DOCUMENT 00 90 00
ADDENDUM

ADDENDUM NO. [1] **Date: March 23, 2018**

RE: WISCONSIN INDIANHEAD TECHNICAL COLLEGE
WITC – NEW RICHMOND CAMPUS
ADMINISTRATION AND TRADES AREAS
RENOVATION AND MAINTENANCE
HSR PROJECT NO. 17063-3 & 4

FROM: HSR Associates, Inc
 100 Milwaukee Street
 La Crosse, WI 54603
 (608) 784-1830

REMOVAL PLAN AREAS 'A', 'B', 'C', 'E' AND 'F'

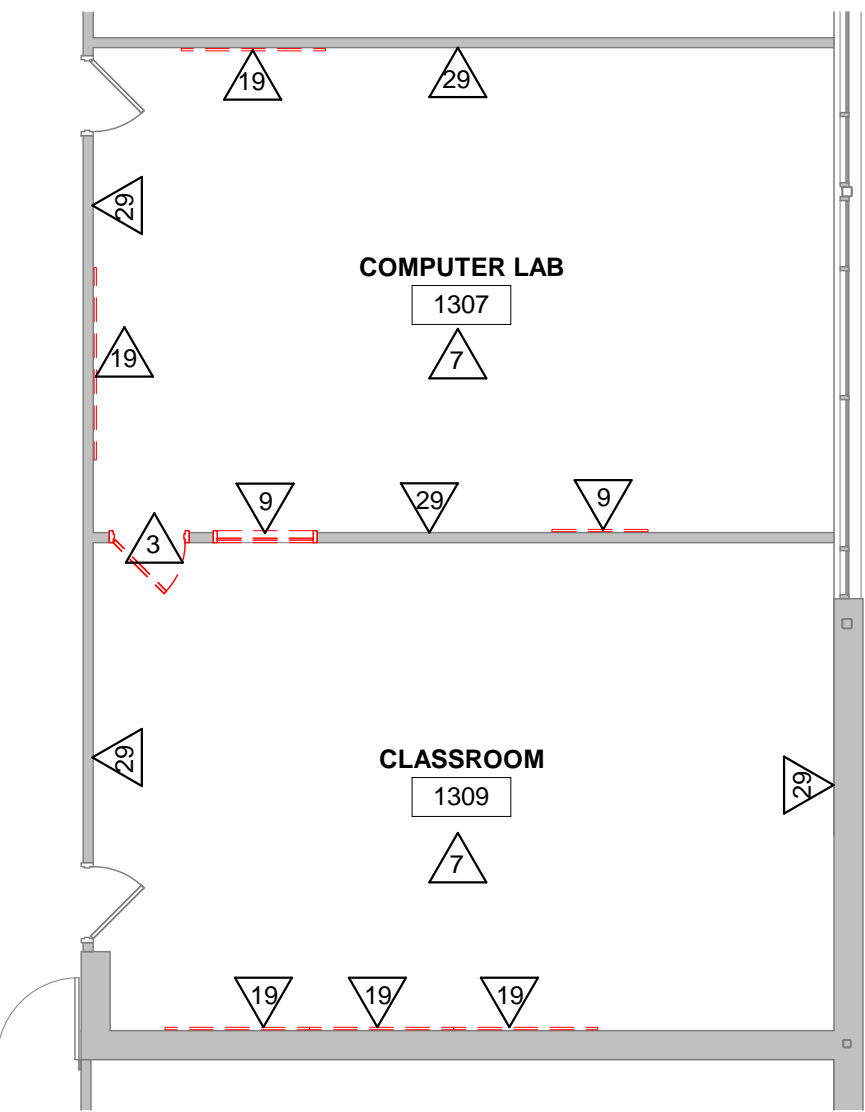
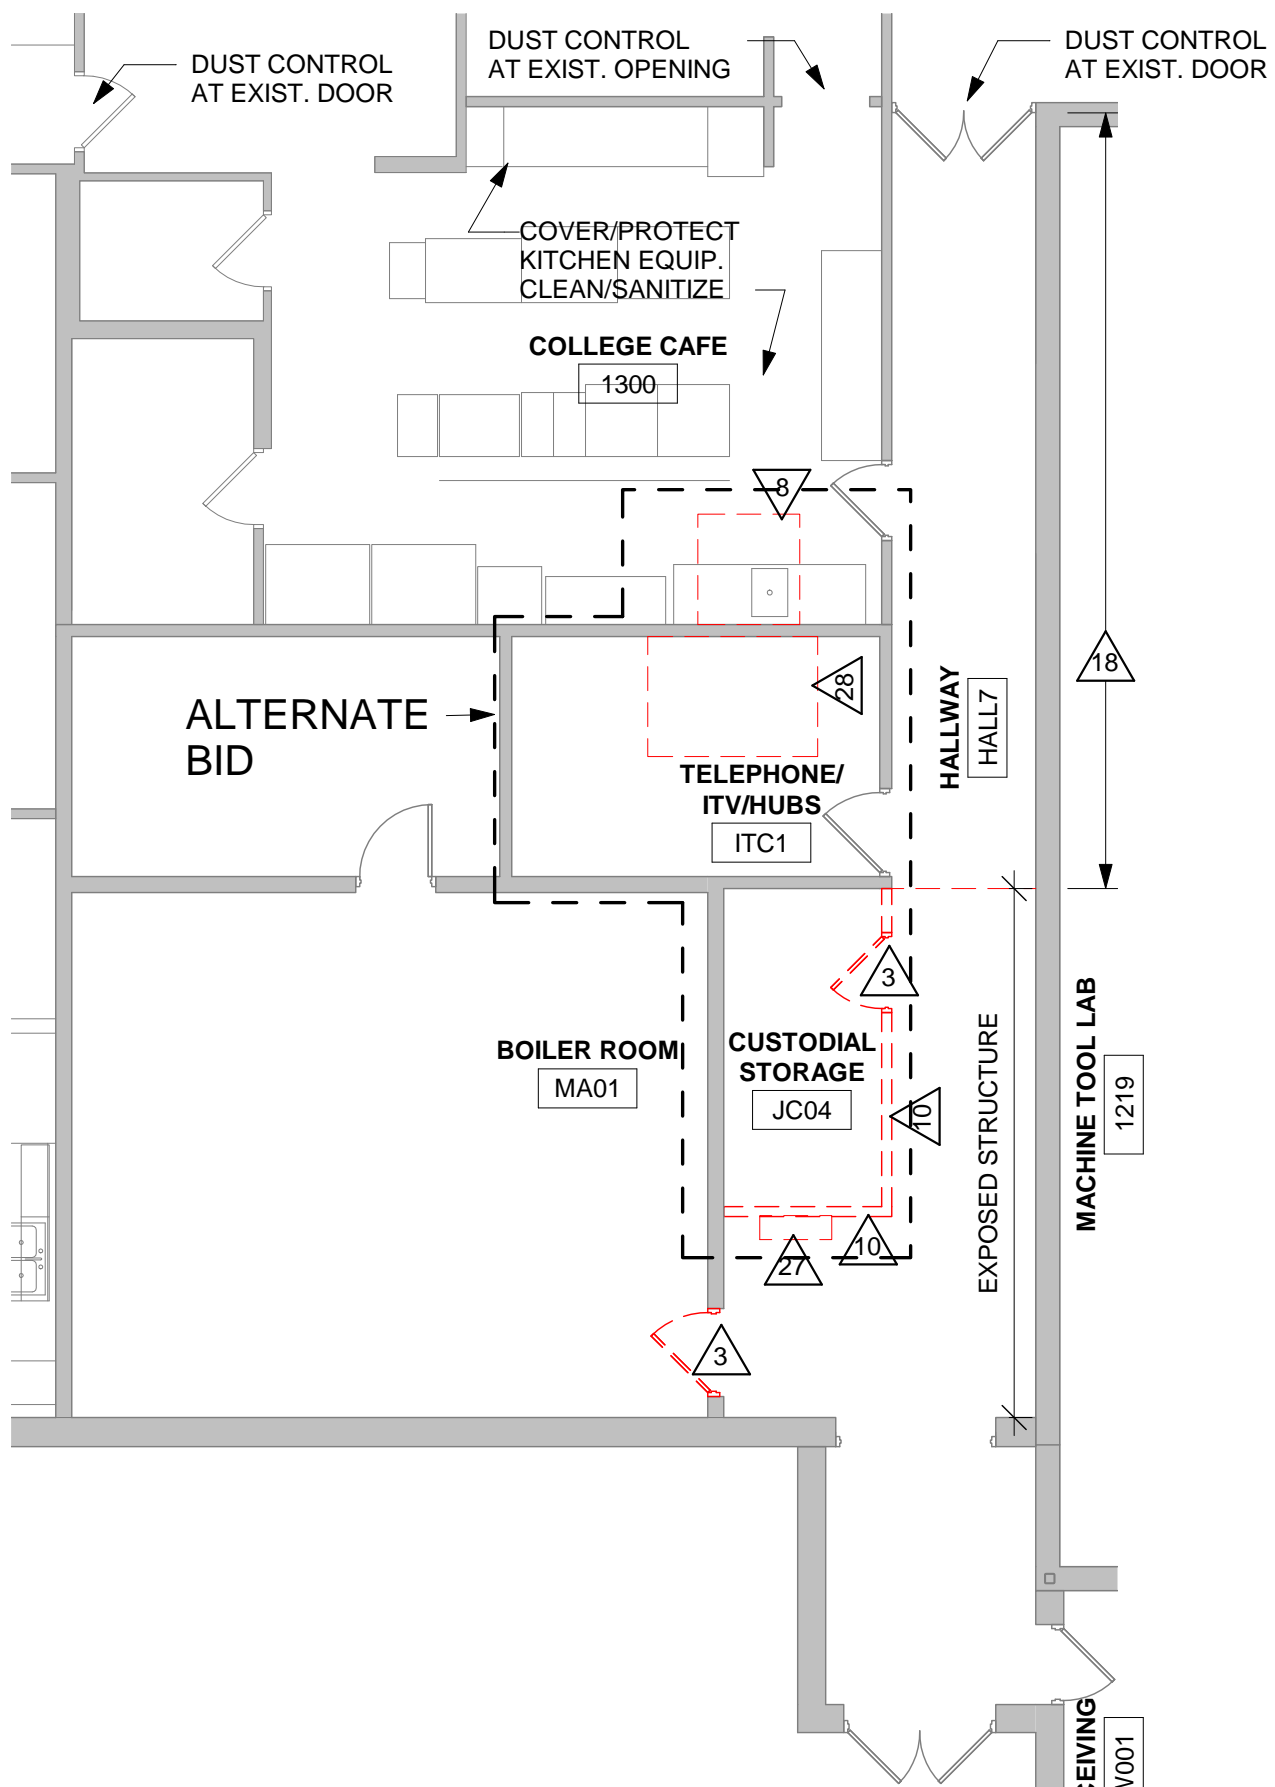
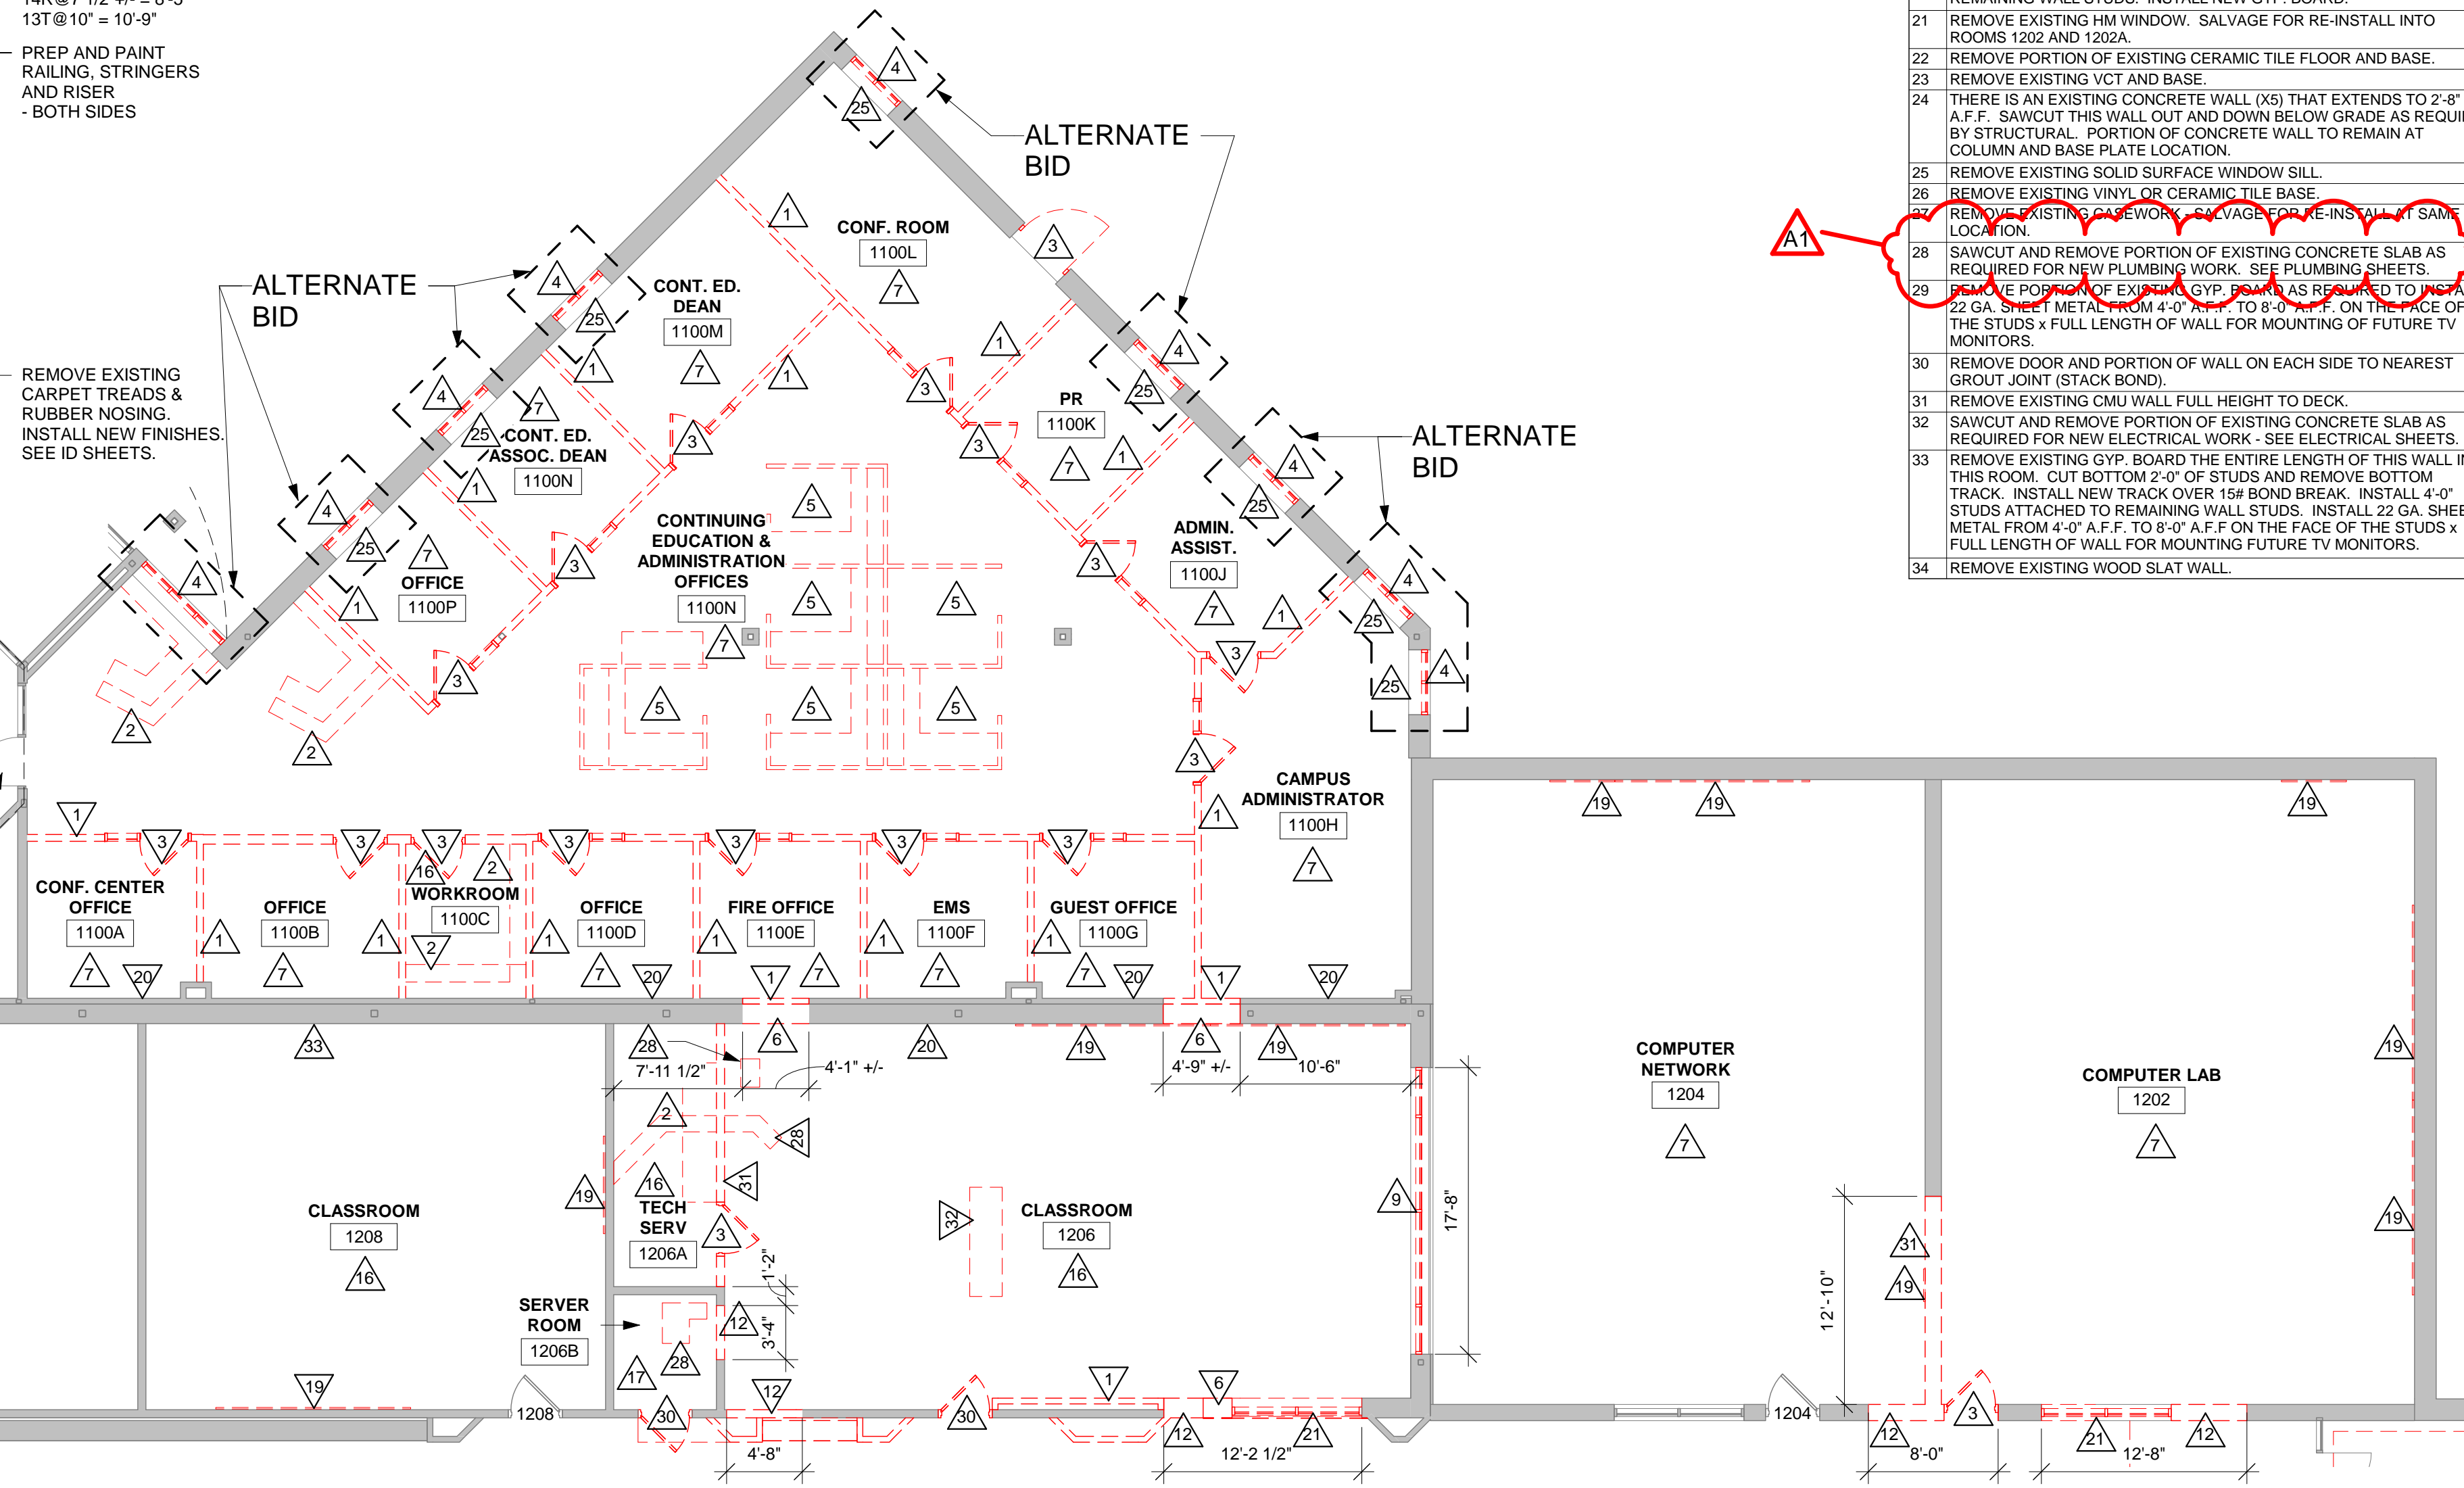
- 11. Sheet A090R REMOVAL PLAN AREAS 'A', 'B', 'C', 'E' AND 'F' 30 x 42 attached hereto
 - a. Revisions clouded on Drawing
- 12. Sheet A100R REMODEL PLAN AREAS 'A', 'B', 'C', 'E' AND 'F' 30 x 42 attached hereto

Project Title: **WITC - NEW RICHMOND CAMPUS
ADMINISTRATION AND TRADES AREAS
RENOVATION & MAINTENANCE**
Project Location: **1019 SOUTH KNOWLES AVENUE
NEW RICHMOND, WISCONSIN 54017**
Sheet Title: **PLUMBING PLANS - AREA F**

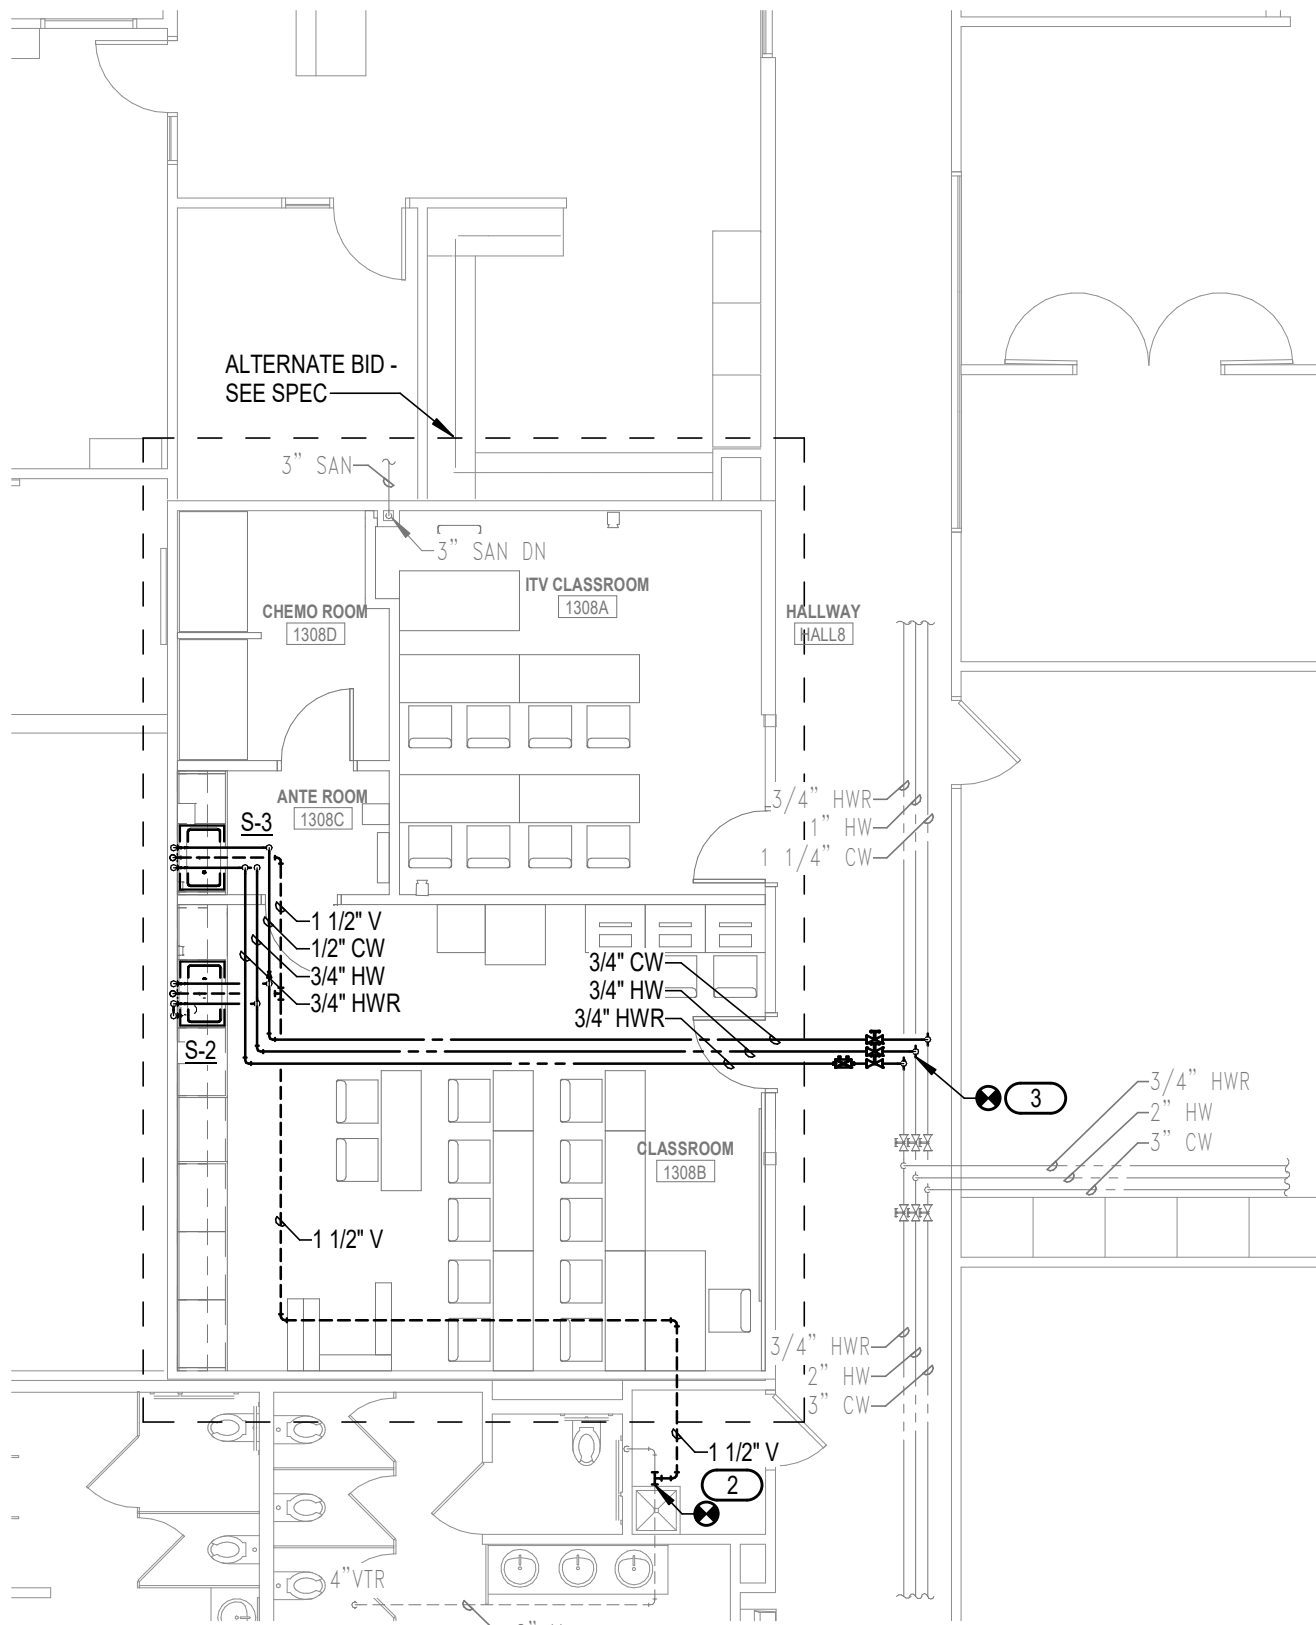
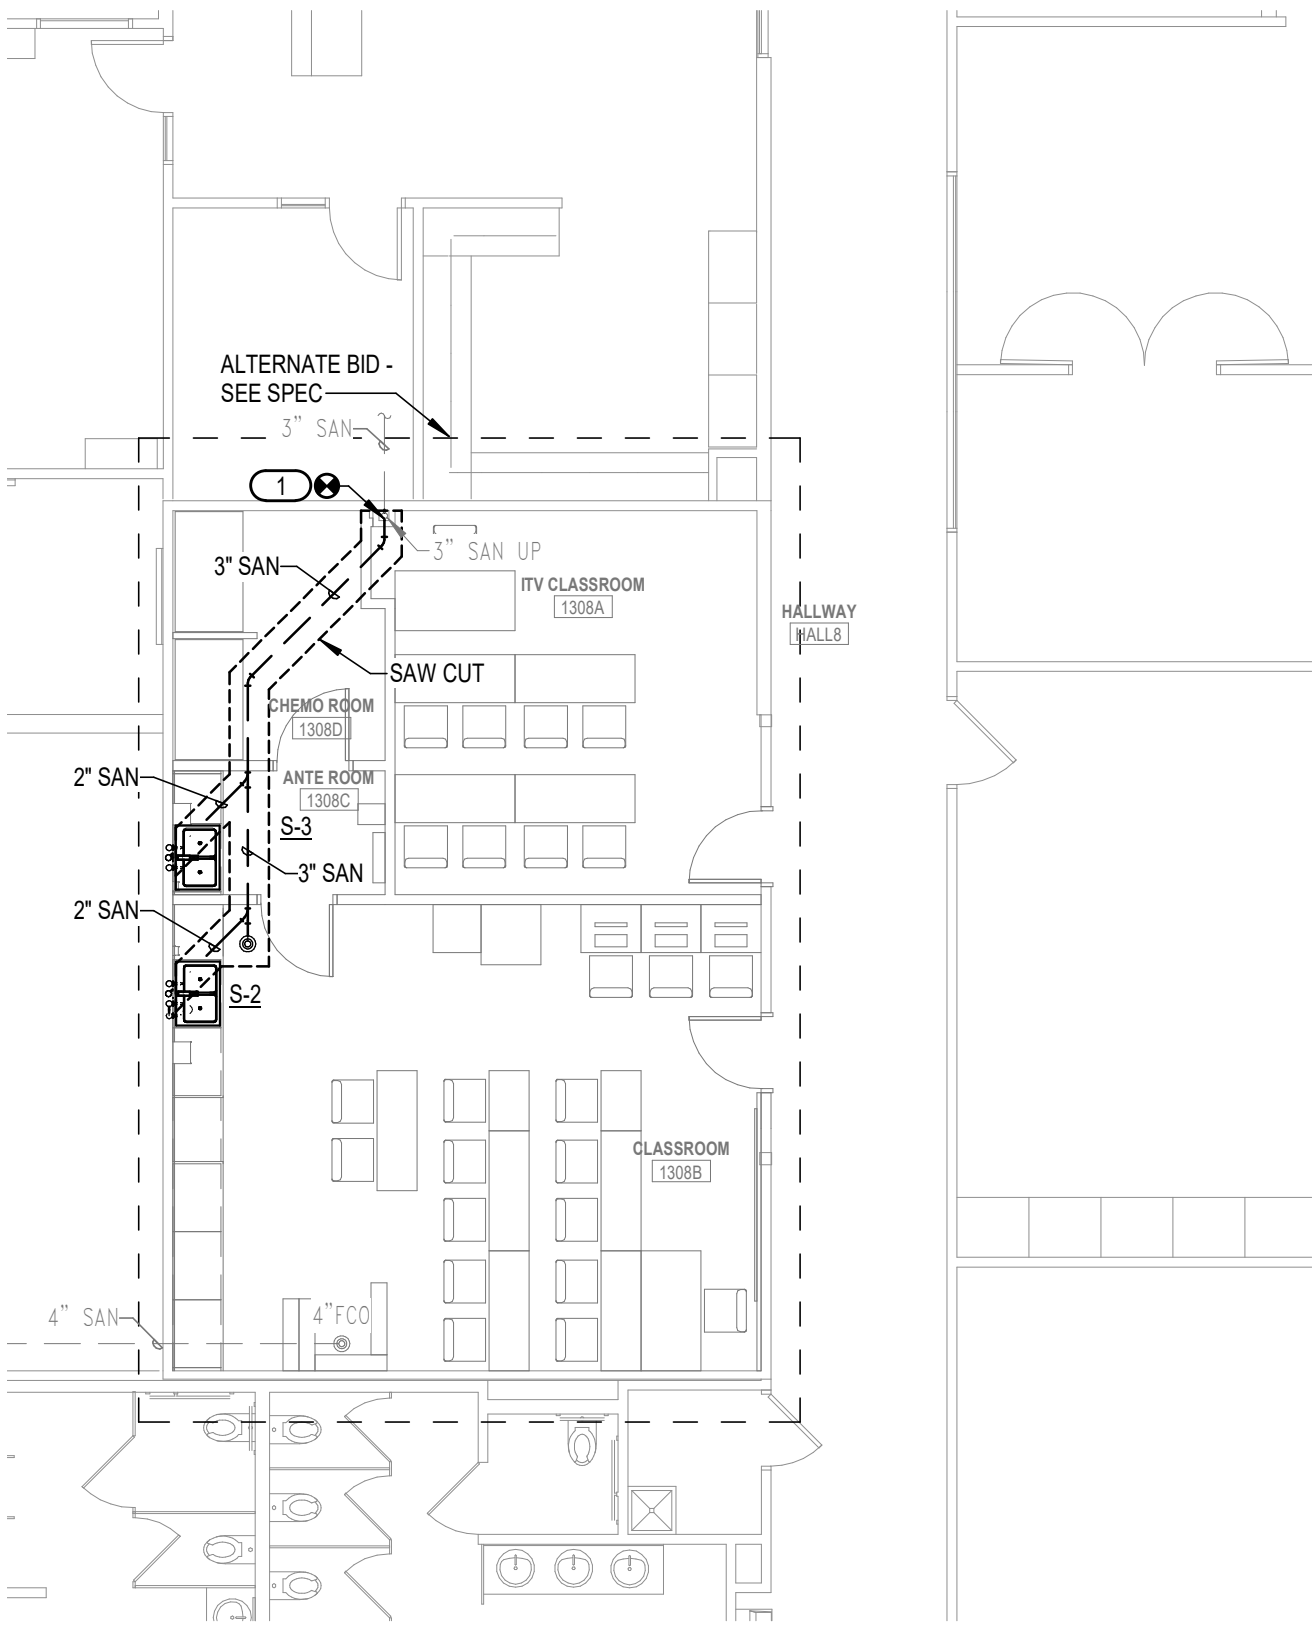
21. Sheet P102

- a. Add Drawing to Contract Documents.
